RE: **Lot 11 Block 7, Volcano Cliffs, Unit 18, SAD 228
6505 Papagayo NW
Grading and Drainage Plan
Engineers Stamp Date 1/8/20 (D10D003L11)**

Based upon the information provided in your submittal received 1/9/20, this plan is approved for Grading Permit.

DRAINAGE AND TRANSPORTATION INFORMATION SHEET (REV 6/2018)

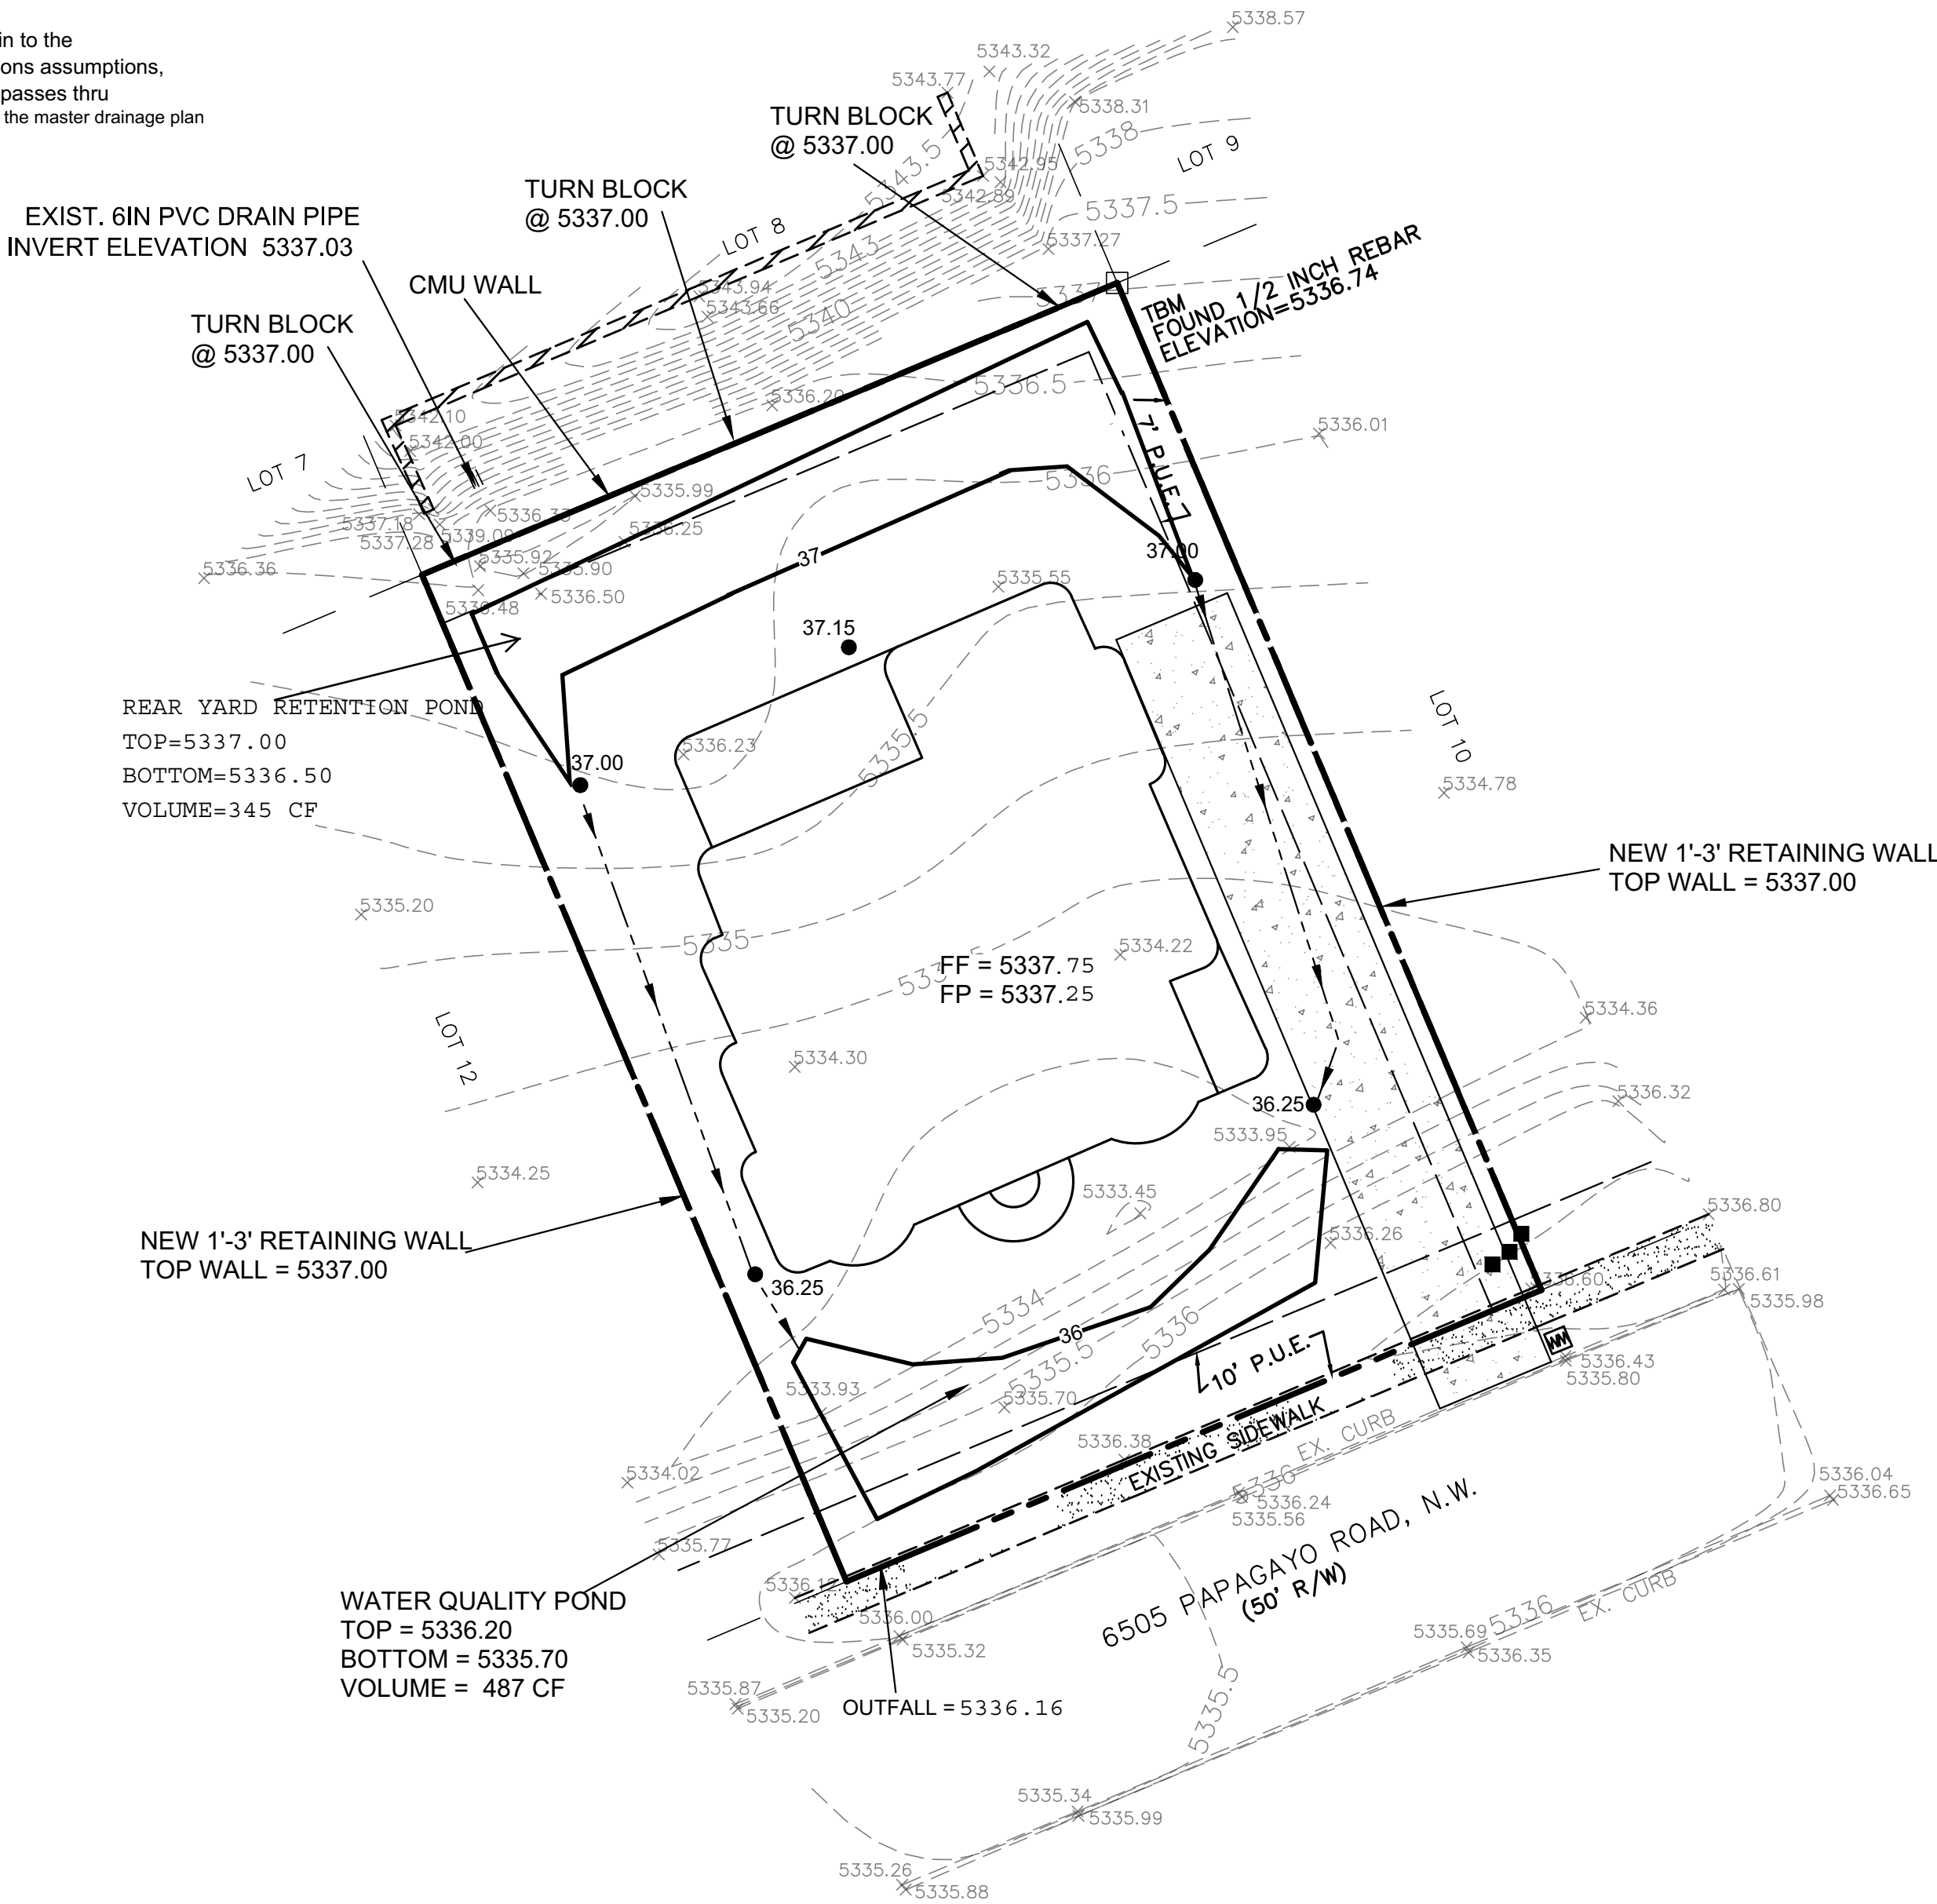
Prior to Building permit approval a Pad Certification will be required, provided by the Engineer or a registered Land Surveyor.

Advise the owner contractor not to use dirt as a ramp to climb the curb, use lumber or crusher fines for this purpose.

Reiterate to the Owner/Contractor that a separate permit for a garden/retaining wall must be obtained with the approved G&D plan and Pad Certification. Also, if a swimming pool is to be placed the grading and drainage plan will change and will need to be resubmitted.

Prior to Certificate of Occupancy release, Engineer Certification per the DPM checklist is required.
